3.2 24 Lyndhurst Crescent, Hawthorn - alterations and additions to a heritage dwelling - amended proposal at VCAT (P22/0415)

REPORT TO CONSIDER REVISED POSITION ON PLANNING PERMIT OUTCOME

Application Number	PP22/0415 (VCAT Reference: P1466/2023)
Planning Officer	Daniel Murphy
Property Address	24 Lyndhurst Crescent, Hawthorn
Zoning	Clause 32.09 - Neighbourhood Residential Zone Schedule 3
Overlays	Clause 43.01 - Heritage Overlay Schedule 155
Particular Provisions	None
Permit Triggers	Clause 43.01-1 (HO) of the Boroondara Planning Scheme, a permit is required to: <ul style="list-style-type: none"> • Demolish or remove a building. • Construct a building or construct or carry out works.
Aboriginal Cultural Heritage	No
Covenant	No
Potential Overland Flow?	No
Ward	Glenferrie
Number of Objections Received	22 objectors were received following public notification. Four (4) statements of grounds have been received by Council, including a joint statement of grounds. All four (4) objectors have elected to participate as parties to the VCAT proceedings.
Plans Assessed in this Report	The plans before Council are the VCAT amended plans circulated on 2 April 2024 identified as: Drawing no. TP01-T

Drawing Title
OBLIQUE VIEWS
Scale 1:100 @ A1 / 1:200 @ A3

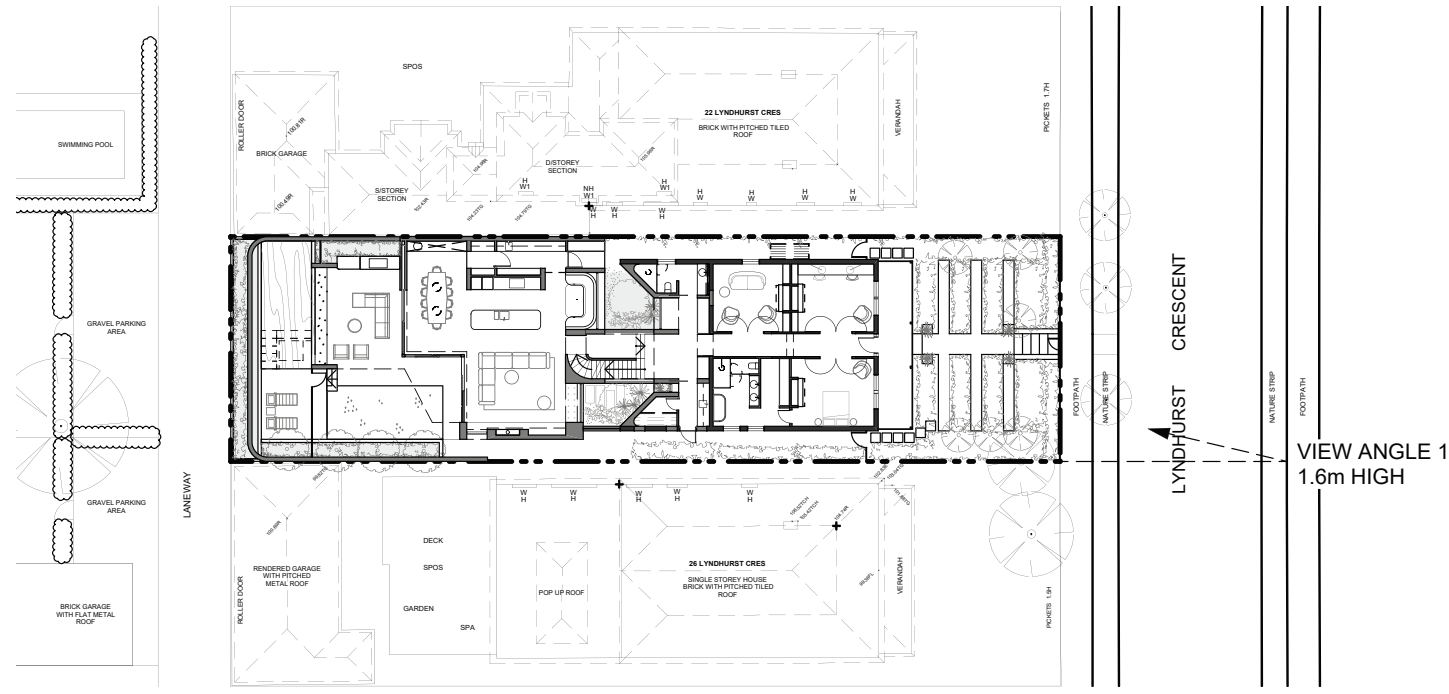
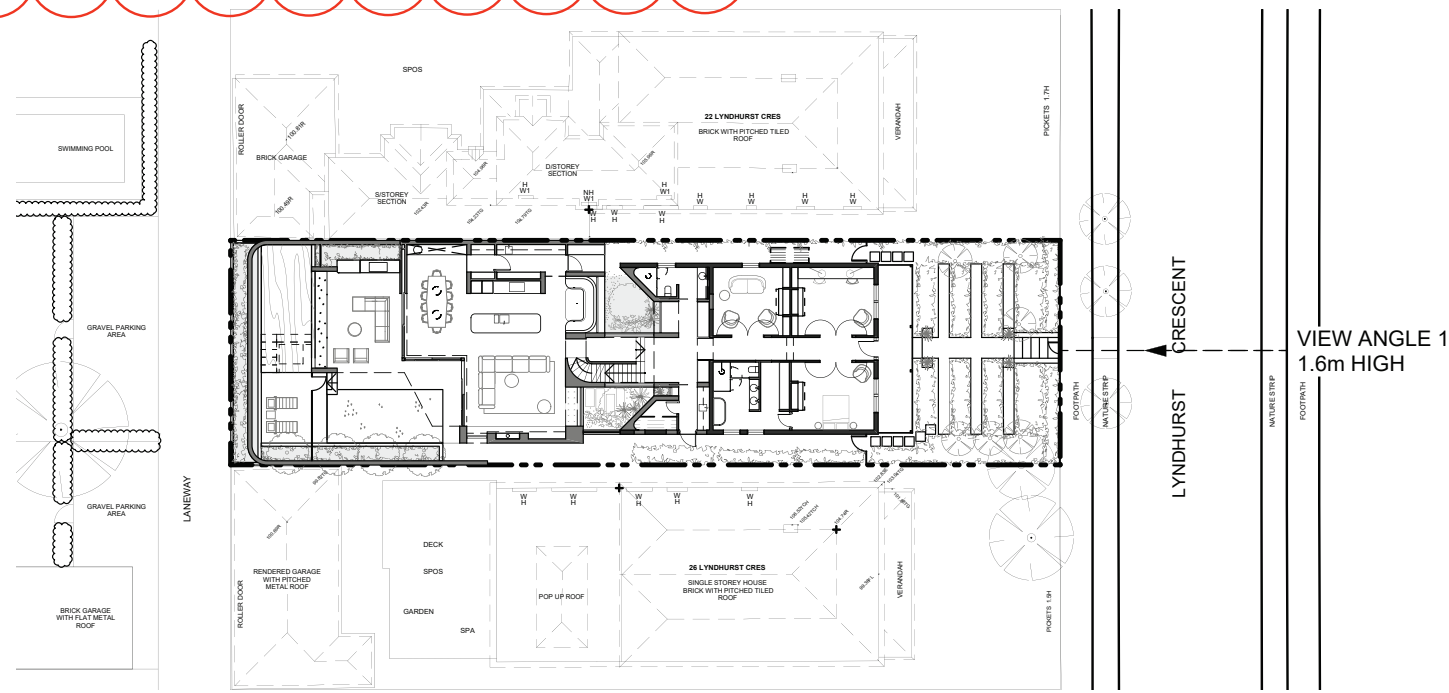
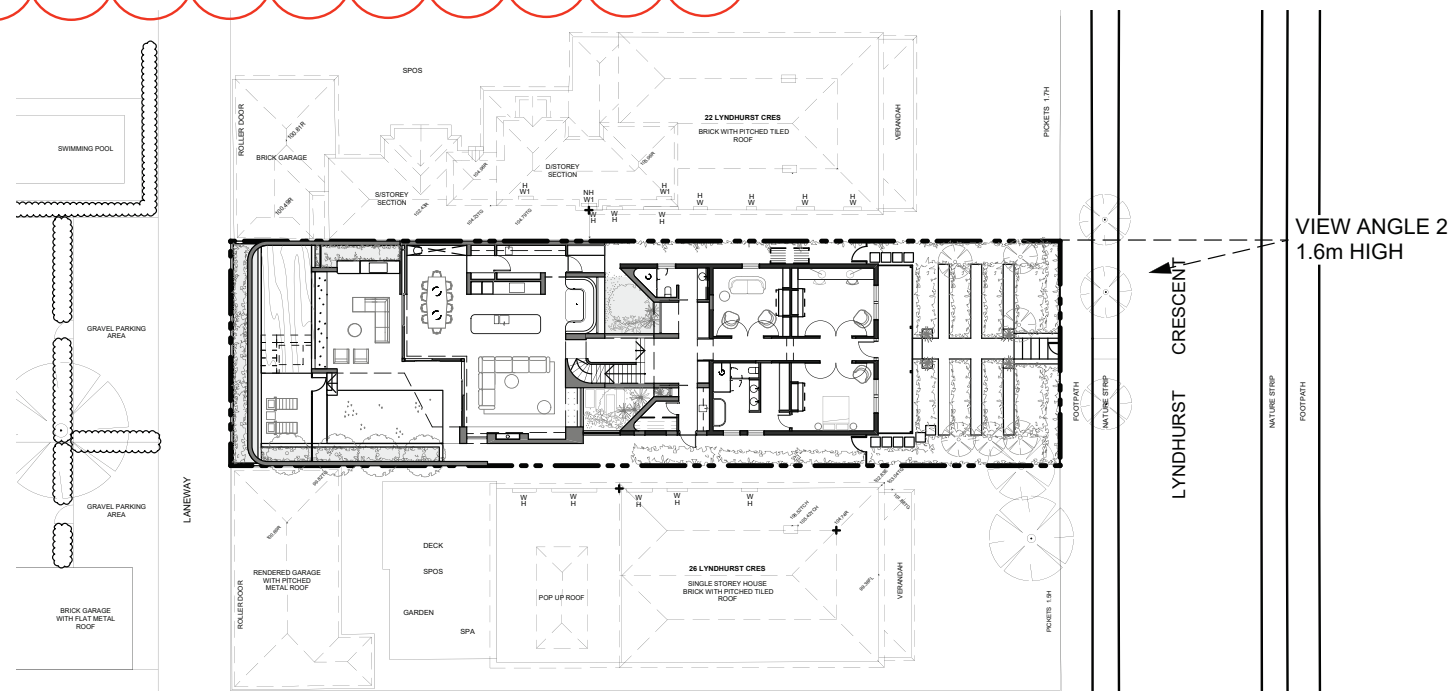
In the oblique, the first-floor addition will be set back approximately 27 metres from the front boundary (excluding the centrally located stairwell element which is setback approximately 23 metres). Given that some limited oblique views may be visible from the street, Council's Heritage advisor has recommended a lighter colour palette be provided as a condition to ensure that the 'reading' of the contributory heritage fabric is not compromised.

Oblique views: the oblique view images show that the addition is insufficiently recessive. While the oblique images demonstrate that the addition remains visible in oblique views, it is considered that the relevant modifications to the plans have addressed the key concerns with this visibility, with the exception of the material and colour palette.
